Review of Landscape and Visual Appraisal (ARB1575lva) in relation to hybrid planning application ref: 24/01157/HYB

Kyngs Golf Club, Market Bosworth

Prepared by Aspect Landscape Planning Ltd on behalf of Hinckley &
Bosworth Borough Council

August 2025

Figure 2: Extract from Site Layout Plan. Drawing no: HMD/PD/0574/02 (Nov 2024).

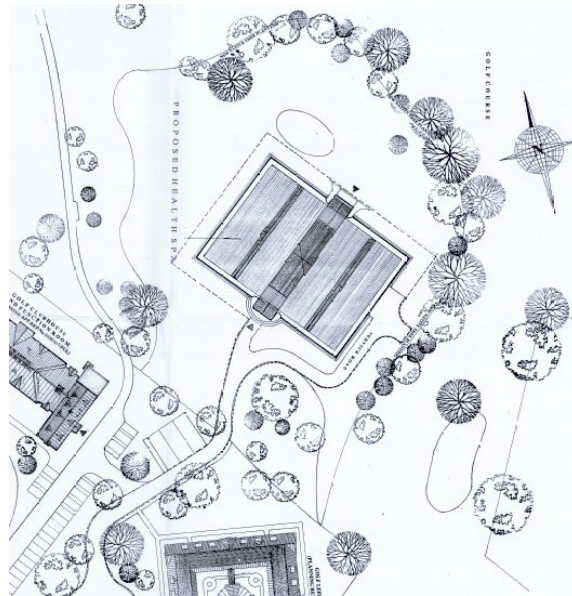
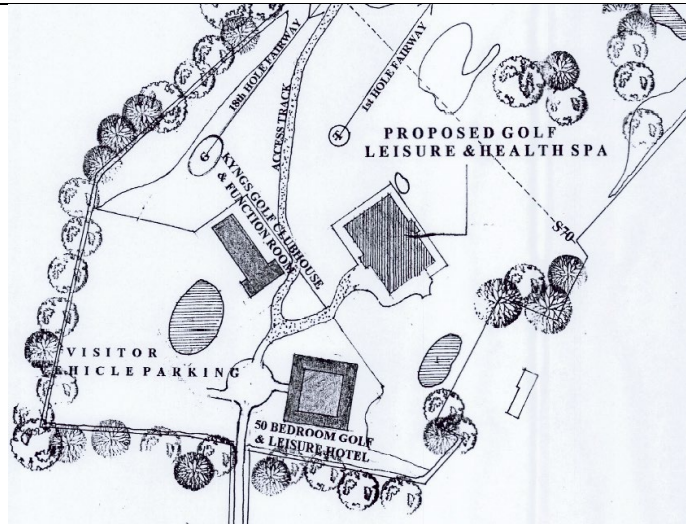
The submitted Site Layout Plan for the golf leisure and health spa indicates mitigation planting but is not referenced within the LVA, nor is the submitted Site Location Plan (refer to **Appendix 2**). On a separate note, it would be useful to see the planting indicated on the former in relation to PRoW FP S70, as it appears the mitigation planting runs up to if not over this footpath in places, which would result in the loss of views of the wider landscape to the west from VP8 (identified Vista G) once this vegetation matures. It is noted that on the submitted Site Plan, this mitigation planting is not included (See **Figures 2 and 3** below):
